# 600 WOODSTOCK AVENUE, GLENDENNING

## CIVIL ENGINEERING PACKAGE DEVELOPMENT APPLICATION

**Re: 600 Woodstock Av Glendening – Civil Engineering SSDA Comments**

This letter references the queries raised in a letter dated 12 of April 2022 from Blacktown City Council. This is in response to queries raised with respect to the proposed stormwater system for the site of the proposed development - SSD-29999239.

**DAC05.31**

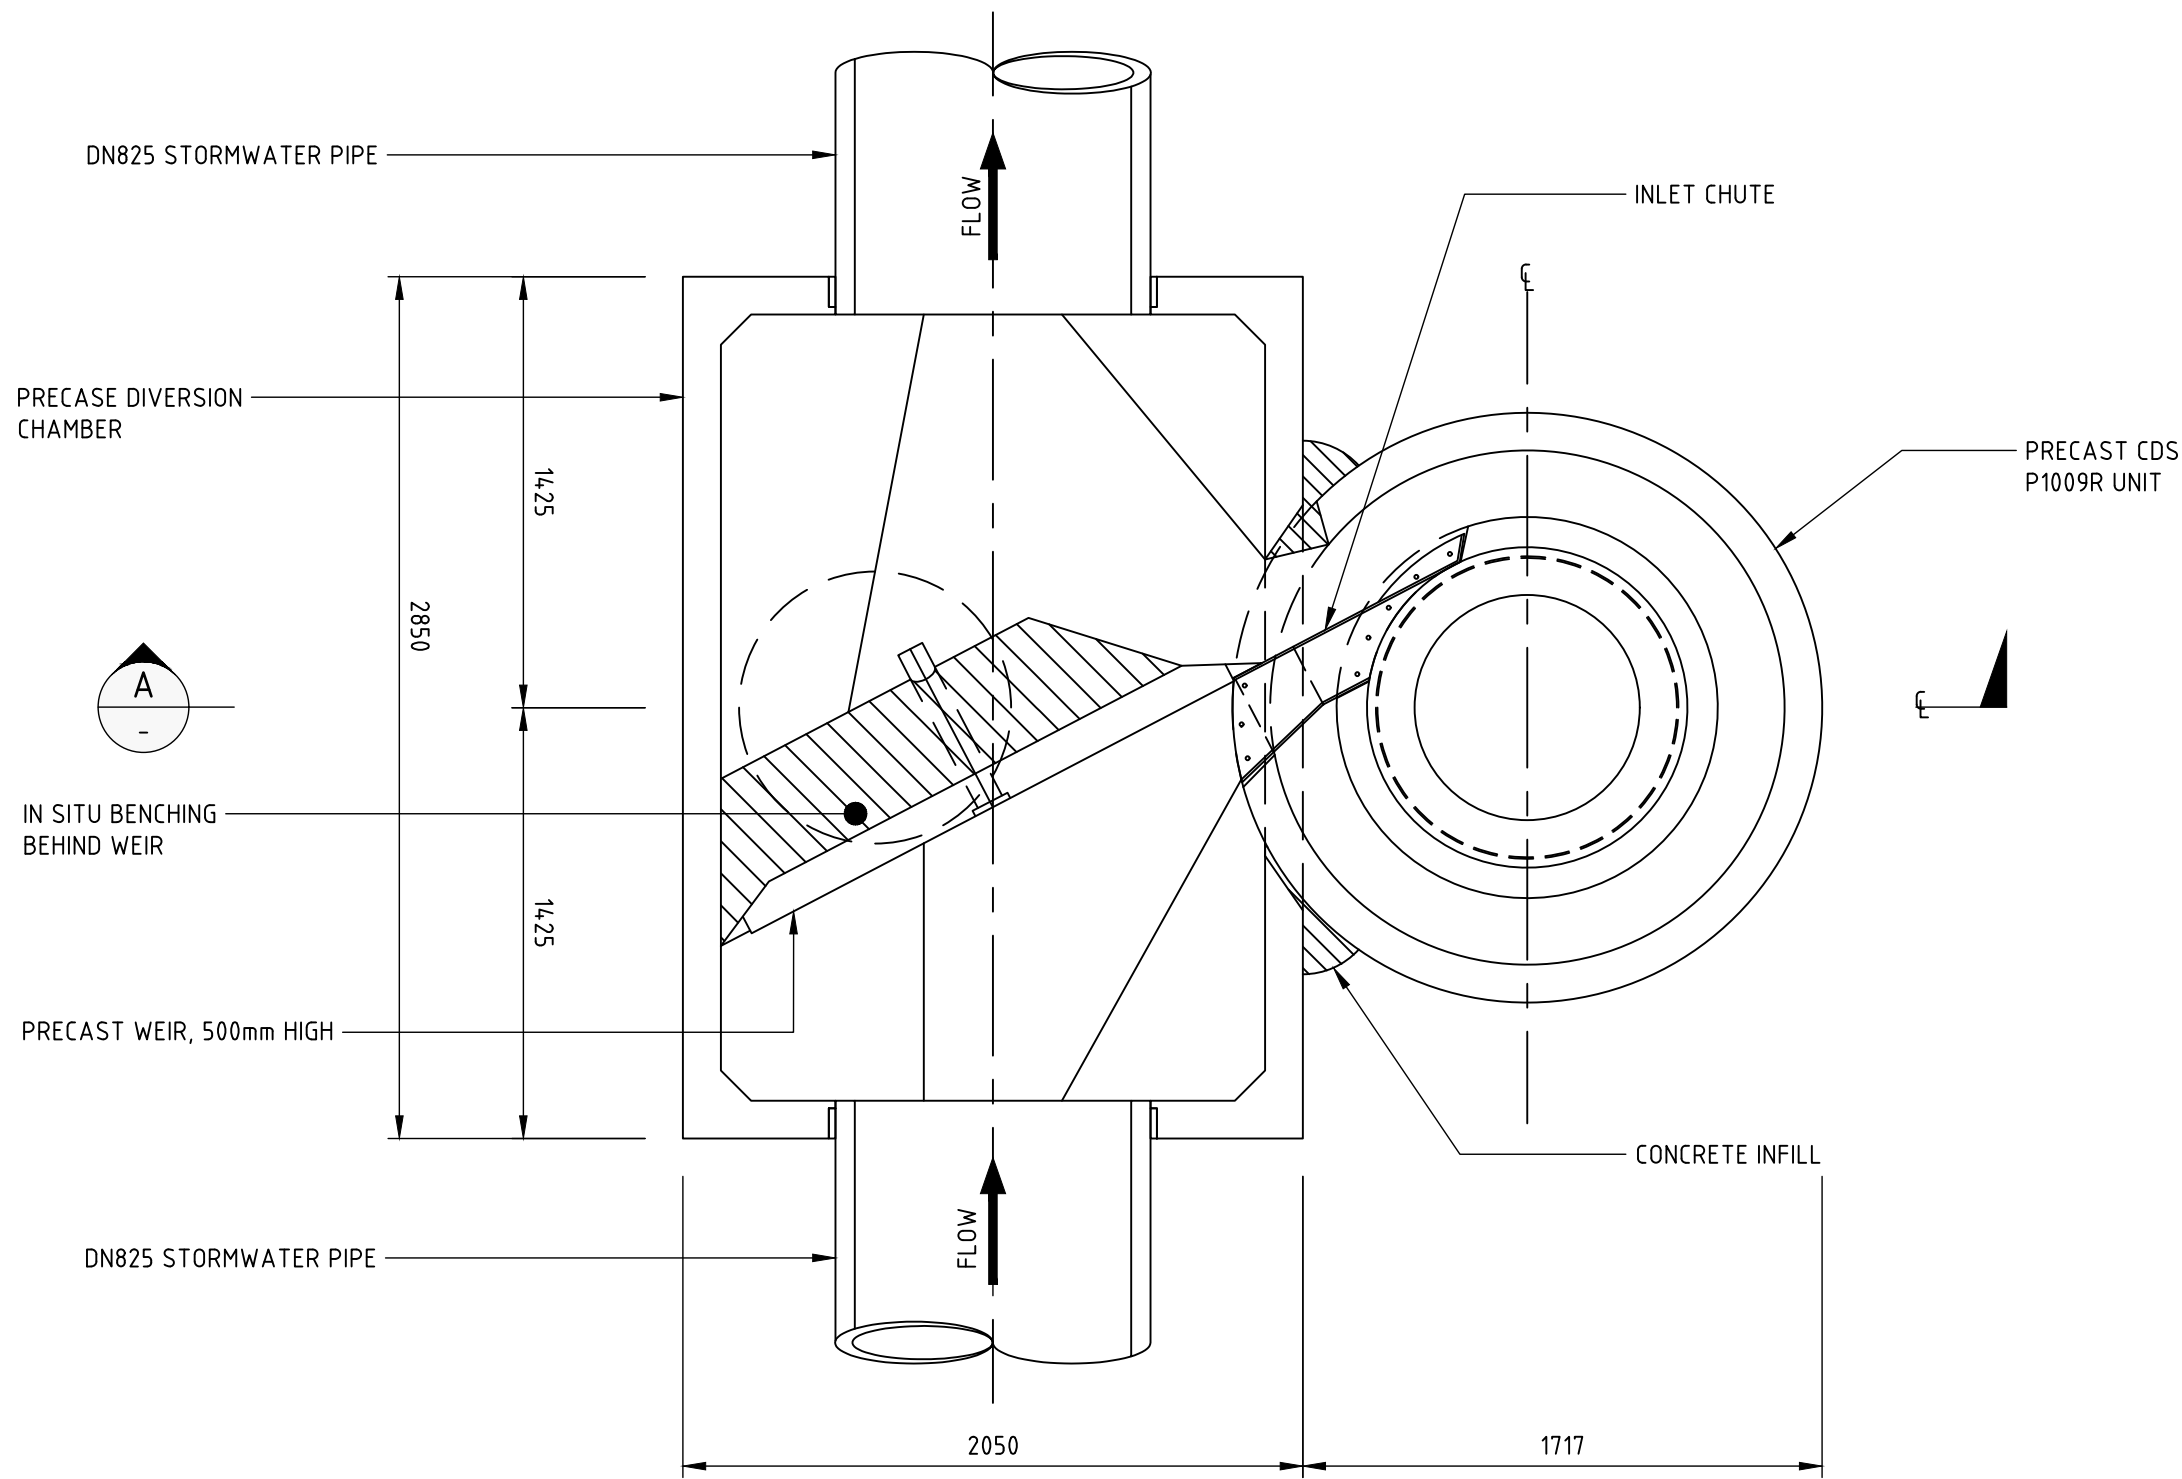
- The lids for the On Site Detention tank are to be grated. Remove the sealed lids. Reflect the pit/grate locations correctly and match with drawing DAC05.31 (02).

h. Drawings DAC05.31 (02) and DAC05.32 (02):

- The lids for the On Site Detention tank are to be grated trafficable lids.

- Provide 2 x 600 x 1200 mm grates over the 1% Annual Exceedance Probability orifice control pit and overflow pit.

- Provide a 900 mm x 900 mm grate over the 50% Annual Exceedance Probability orifice.

- Remove the rainwater tank weir and extend the wall to the soffit of the tank. Provide series of overflow pipes (i.e. 4 x 150 mm diameter) with non-return flaps.

- The sealed lid to the rainwater tank pump must have a minimum internal opening of 2 x 600 mm x 1200 mm to facilitate maintenance access to the pumps

*(Northrop response) Noted, drawings DAC04.01 and DAC05.31 have been updated.*

*(Northrop response) Noted, please refer to updated drawings DAC05.31 and DAC05.32.*

(Northrop response) Noted, please refer to updated drawing DAC05.31.

*(Northrop response) Noted, please refer to updated drawings DAC05.31 and DAC05.32.*

(Northrop response) Noted, please refer to updated drawing DAC05.31.

(Northrop response) Noted, please refer to updated drawing DAC05.31.

DRAWING NOT TO BE USED FOR CONSTRUCTION UNLESS VERIFICATION SIGNATURE HAS BEEN ADDED.	THE COPYRIGHT OF THIS DRAWING REMAINS WITH NORTHROP CONSULTING ENGINEERS PTY LTD.				DRAWING NUMBER	REVISION
											DAC05.32	04

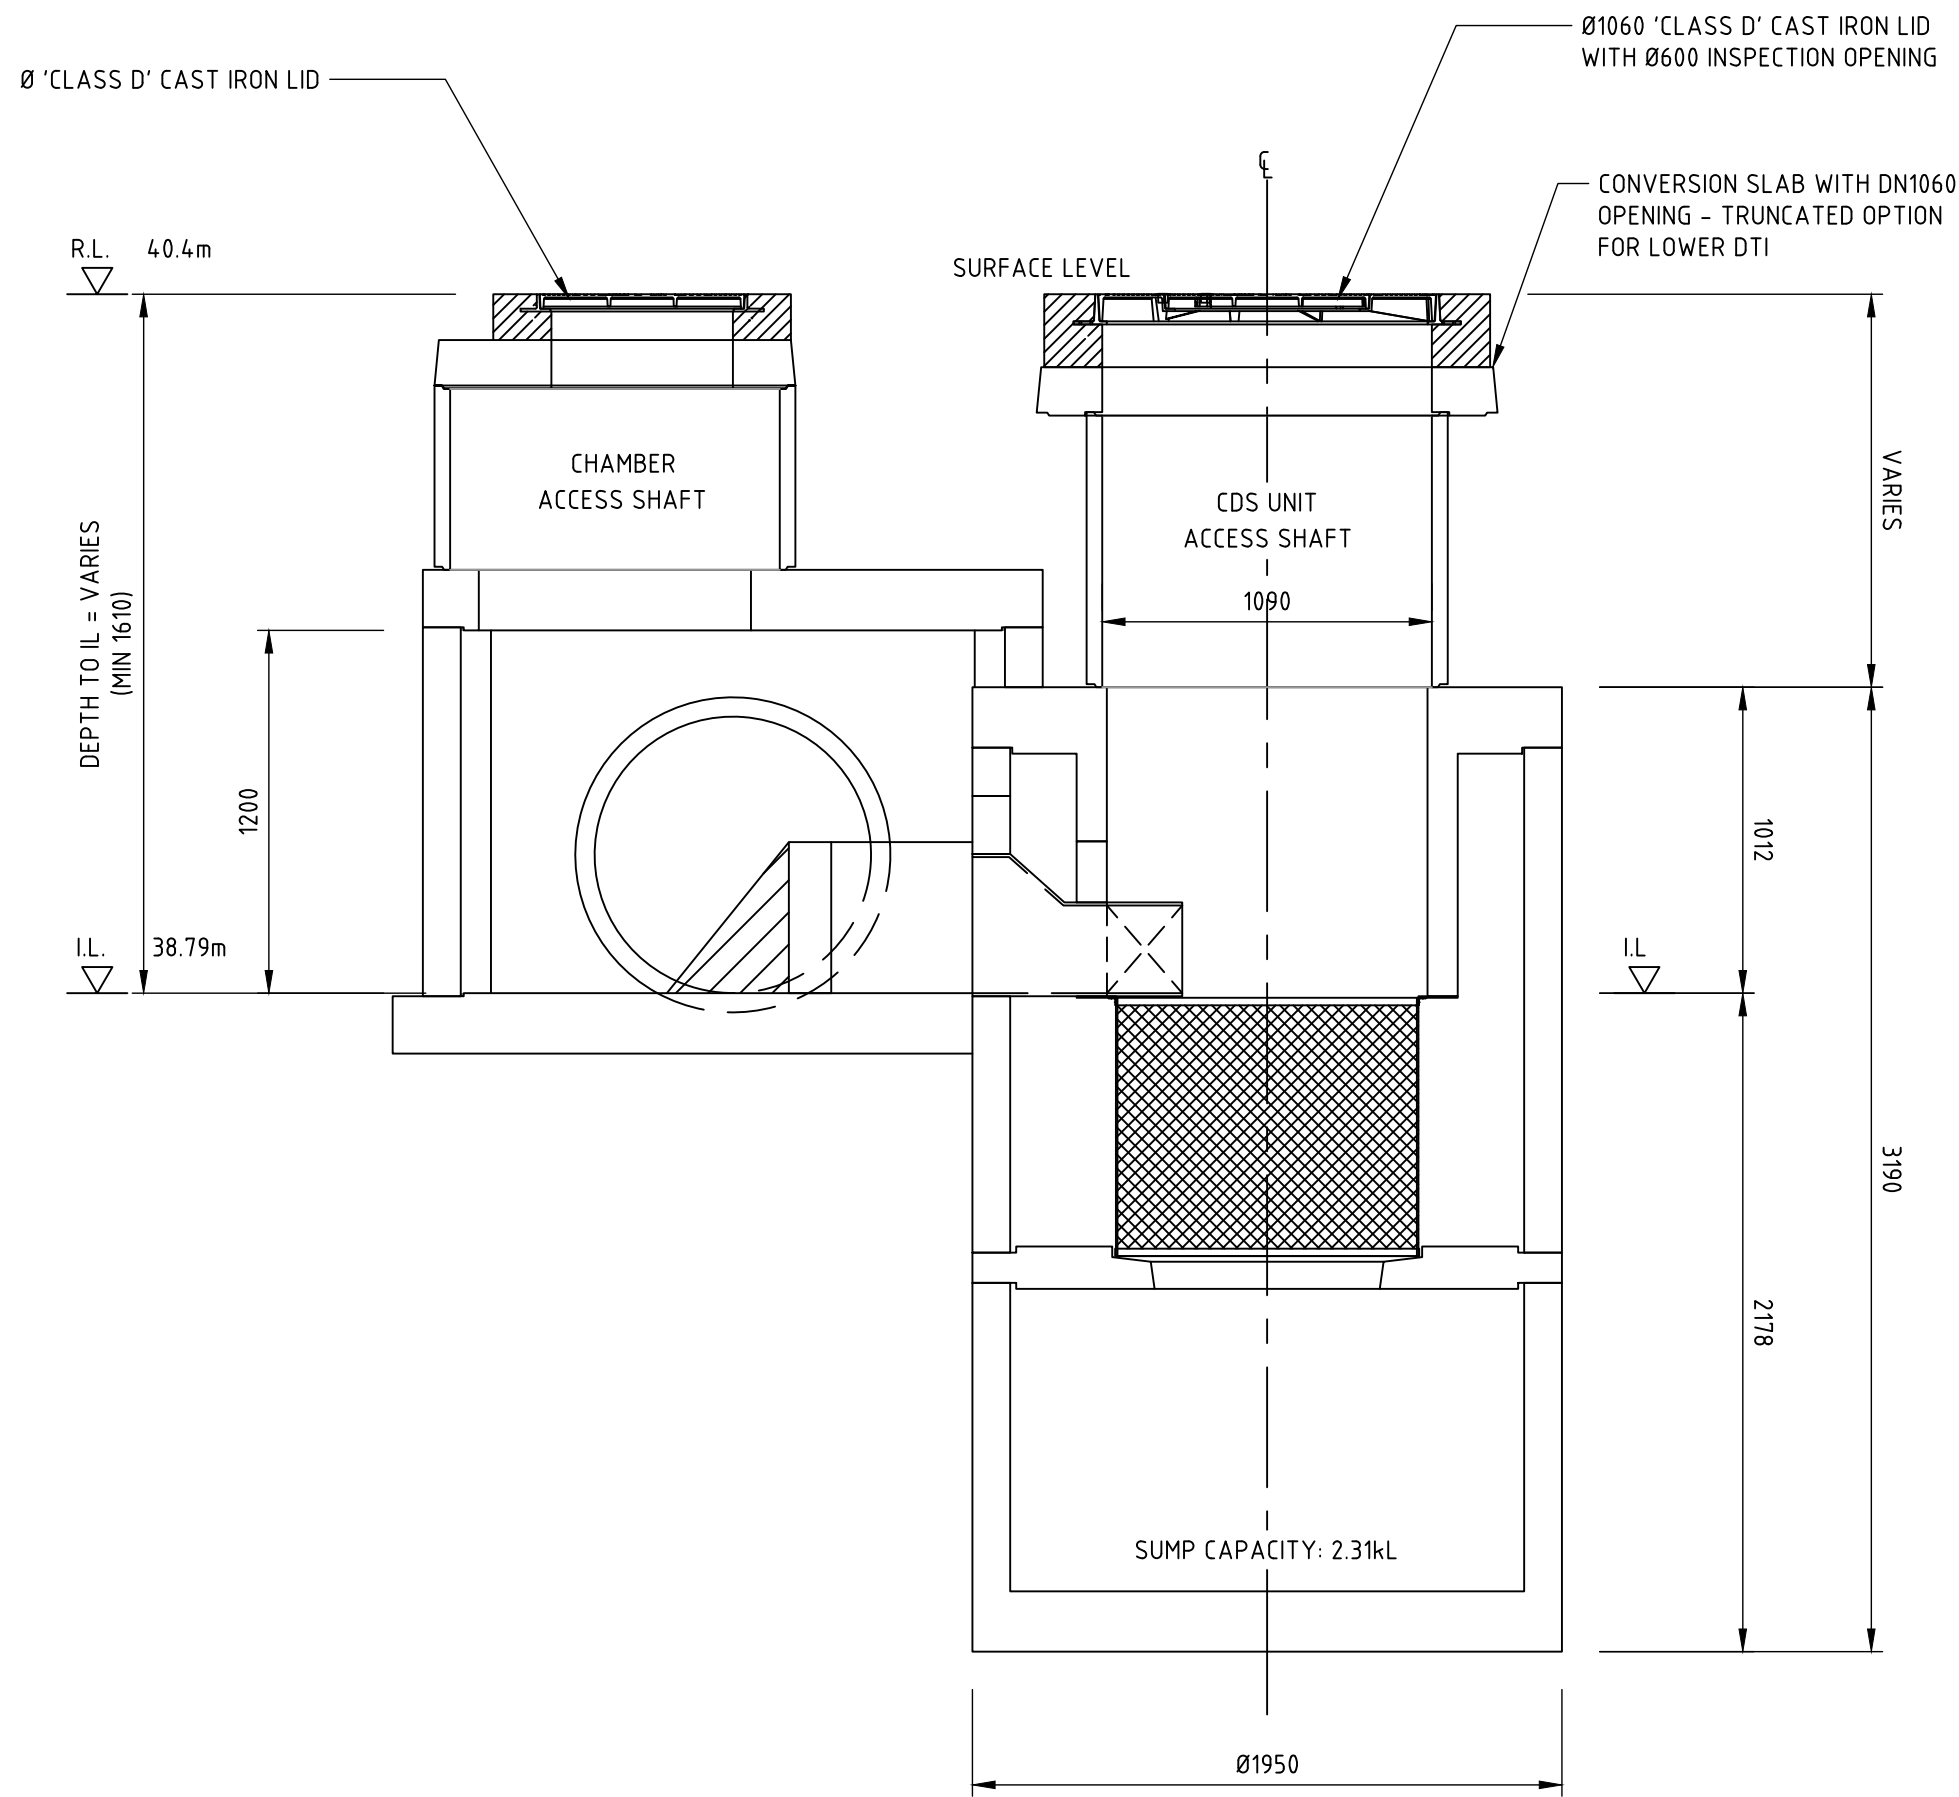
- Rename 100 year Average Recurrence Interval to 1% Annual Exceedance Probability on all notes and plans.

- Rename 1.5 year Average Recurrence Interval to 50% Annual Exceedance Probability on all notes and plans.

- The starting / lowest level in the base of the On Site Detention tank is to be the centreline of the 50% AEP orifice (1.5 year orifice) grading up at 2% from there.

- Provide a minimum 2% slope in the On Site Detention storage. For larger tanks this can be in the form of a 2% cross-slope to a central “V” drain with 2% longitudinal slope along the “V” drain. Reassess tank dimensions to achieve the minimum storage volumes.

- The orifice within the Discharge Control Pit is to be protected by a suitable screen. Provide Maximesh Rh3030 for orifice diameters 150 mm or less with a minimum area of 50 times the

orifice area and Weldlok F40/203 for orifices 150 mm diameter or more with a minimum area of 20 times the orifice area.

I. All pits deeper than 1.2 m must provide step irons at 300 centres.

(Northrop response) Noted, please refer to updated drawing DAC05.32.

(Northrop response) Noted, please refer to updated drawing DAC05.32.

(Northrop response) Noted, please refer to updated drawing DAC05.32.

(Northrop response) Noted, please refer to updated drawing DAC05.32.

*(Northrop response) Noted, please refer to updated drawing DAC05.32.*

(Northrop response) Noted, please refer to step iron detail in drawing DAC05.32.

- Provide details of the Gross Pollutant Trap including sections and levels.

- Pit 04/03 is to be a splitter with a diversion weir to divert the flows. Provide Hydraulic Grade Line details and calculations for the proposed Gross Pollutant Trap and splitter pit system to ensure there is sufficient hydraulic head and no obstruction in flows.

*(Northrop response) Please refer to drawing DAC05.33 for details of the Gross Pollutant Trap.*

(Northrop response) A diversion chamber is provided with the Gross Pollutant Trap, please refer to drawing DAC05.33 for details. The weir level to be set at the top water level for the 1 EY, storm event, subject to detailed design.
